Mordialloc Bypass Minister's assessment of environmental effects

June 2019

Figure 2: Proposed environmental governance framework (EES, p. 23-5).

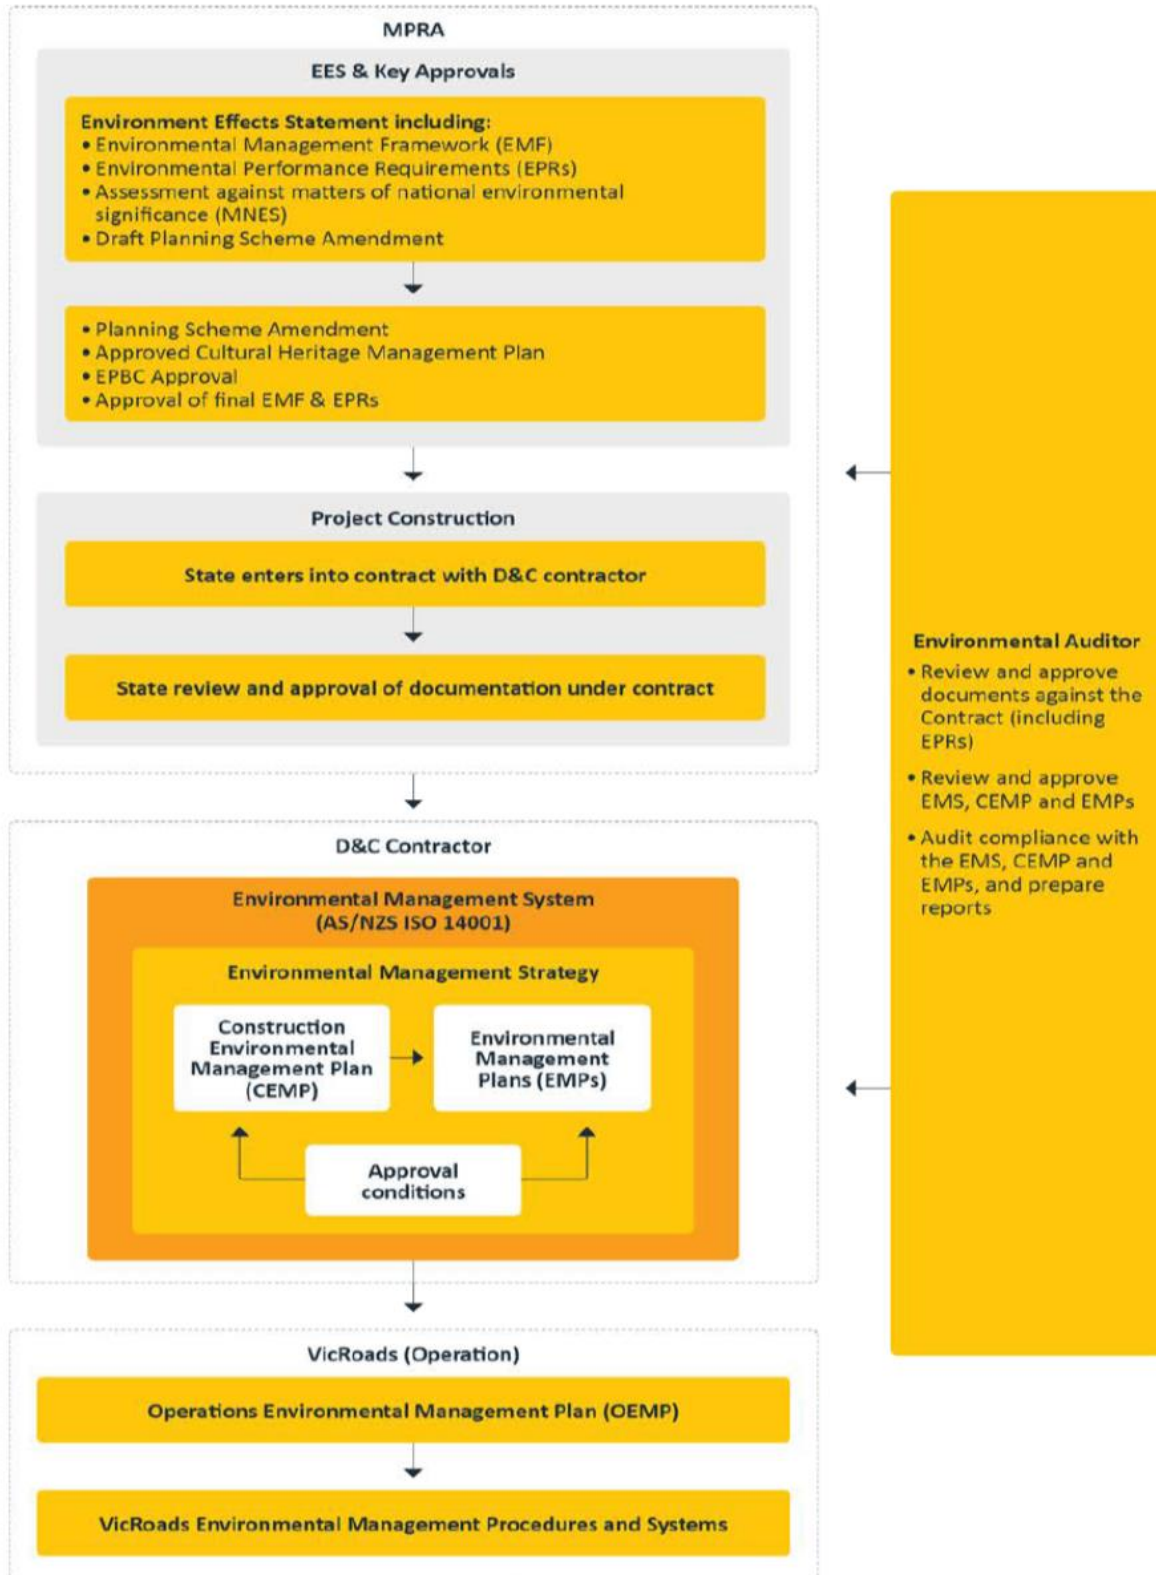
The EMF described in the above figure includes an environmental management strategy to be prepared by the contractor, bridging the approved EMF and the contractor’s specific management plans and approaches for implementing EPRs. The EES describes the role of this contractor document as demonstrating to MRPV how it will implement the EMF. As noted by Kingston City Council this has the potential to create an unnecessary layer and some confusion, given the EMF provides the authoritative framework for environmental governance and management for the project, for any party involved in its construction and operation. The EMF is to be given effect through the contractor’s CEMP and other plans prepared under EPRs and there is also the contractor’s environmental management system, which may add to the confusion.

While MRPV (and contractor) may consider an environmental management strategy to have some utility, it is not clear from the EES how this extra layer will assist either the contractor or regulators. Therefore, I recommend that EPR EM1 be amended to clearly reflect the core role of the EMF (as specified in the proposed planning approval) in providing the framework for both MRPV and the contractor to mitigate effects and achieve environmental outcomes via the specified EPRs and core plans. Should MRPV consider the environmental management strategy to still be essential, this would need to be clearly demonstrated in the final EMF submitted for my consideration.

The proposed EMF in the EES states that it will be updated and re-assessed by the Minister for Planning if traffic lanes are proposed to be added to the project in the future. However, as noted by the IAC this needs to be deleted from the EMF, as the environmental effects of additions or changes to the project (e.g. for a six-lane freeway) have not been assessed. MRPV acknowledged this and accepted the EMF would need to be amended and that if future lanes were to be required, appropriate statutory processes would be addressed (such as potential referrals under the EE Act and EPBC Act).
